C12.1	N0031/15 - 23 Plateau Road Avalon Beach - Alterations and additions to the existing residence
--------------	--

Meeting: Sustainable Towns and Villages Committee

Date: 18 May 2015

Figure 1: Relationship of the proposed development to the two applicable height controls

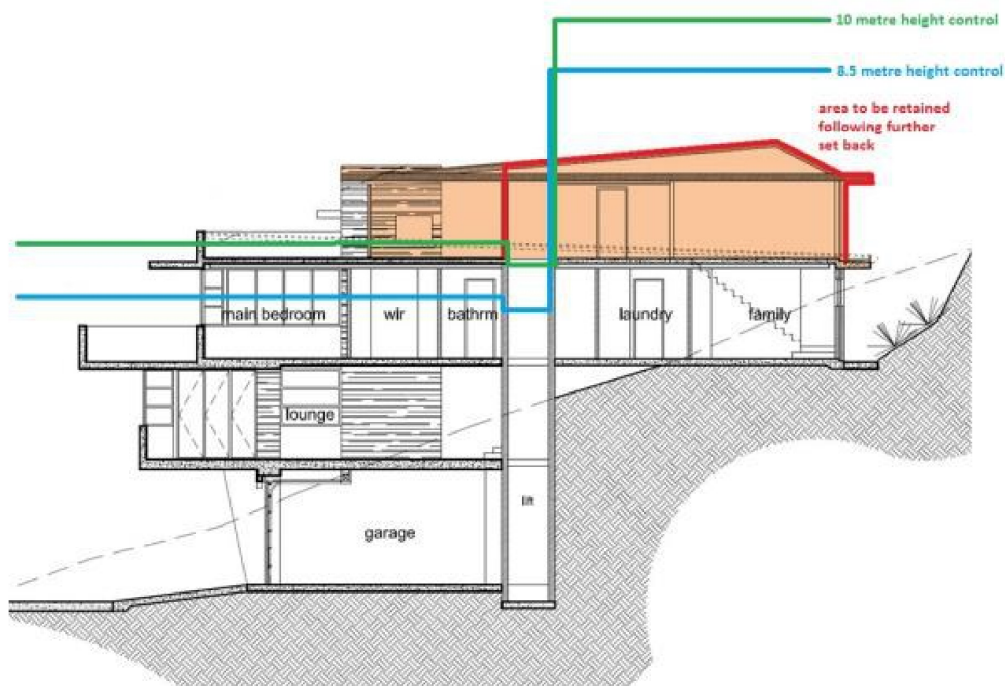
It should be noted that this condition does not require the setting back of the proposed chimney breast. The LEP definition of building height expressly excludes chimneys, meaning that this structure is not included in the calculation of building height. The deletion of this chimney breast at this level would result in amenity and health issues with the discharge of the approved fireplaces below; without the chimney breast now proposed, emissions from these fireplaces would discharge at the floor level of the new level. This chimney has a slender one metre depth as seen from the west and is not held to present an excessive level of bulk or scale.

The 4.6 metre set back has been recommended to allow the retention of the lift core which already runs through the building and is proposed to continue into the new level. This section of the lift core would continue to measure 13 metres from the base of the lift shaft to the roof directly above, with all other parts of the new level located wholly within the 8.5 metre height control. Figure 1 below demonstrates the applicable height controls relative to the proposed development and the recommended amendment:

Given that this 1.4 metre deep section of the amended upper level continues to breach the height control, consideration against clause 4.6 (exceptions to development standards) of the LEP is required. This clause states that consideration may be given to the variation of a development standard but only if it can be demonstrated that strict compliance would be unreasonable or unnecessary, that the development would comply with the objectives of the development standard and that the development would comply with the objectives of the land use zone. These points are discussed below:

Figure 2: Applicant demonstration of proposed development compared to southern neighbouring properties

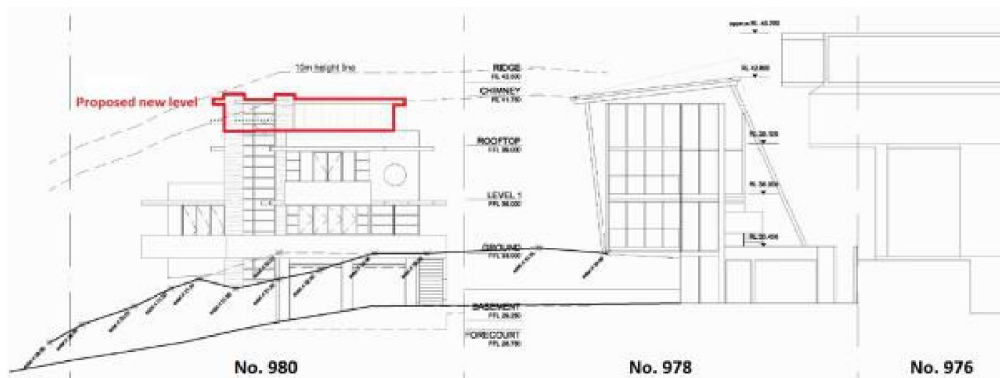
The majority of the above points are discussed further above and below. In terms of the comparison of height and bulk with the neighbouring properties, the below two diagrams assist in demonstrating this:

Figure 5: Proposed amendment of development to include a further set back

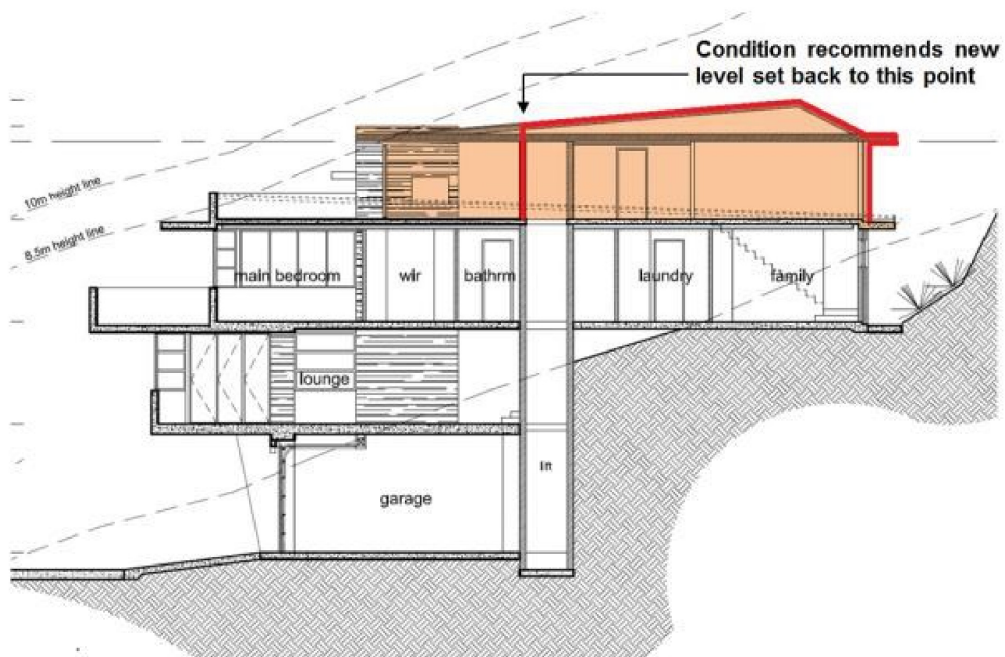
The dwelling as already approved comprises three storeys at the front and one storey at the rear, integrating with the significant slope of the site. The proposed new level is positioned such that the resulting dwelling would be four storeys in some places and two storeys in others. This is not held to be consistent with the desired character of the locality. A condition is recommended which requires that the western elevation of the new level be further set back by 4.6 metres, such that it is located above the single storey element of the existing dwelling only. This will mean that the resulting dwelling will be two storeys at the rear (in line with the control) and three storeys at the front (as already approved). The below diagram demonstrates the intent of this condition:

The resulting level will continue to include a generous amount of habitable floorspace and include the lift core which already runs through the building. It must be noted however, that the recommended condition does not include the chimney breast proposed at the front of the site; the deletion of this section of brickwork would mean that emissions from the fireplaces below would discharge onto the new front balcony which would result in unacceptable amenity impacts and potential health hazards. The chimney is not classed as a storey and is expressly excluded from the definition of building height within the Pittwater LEP 2014. From the west this will appear as a slim structure (one metre in width) which will not add a significant or unacceptable amount of bulk to the site.
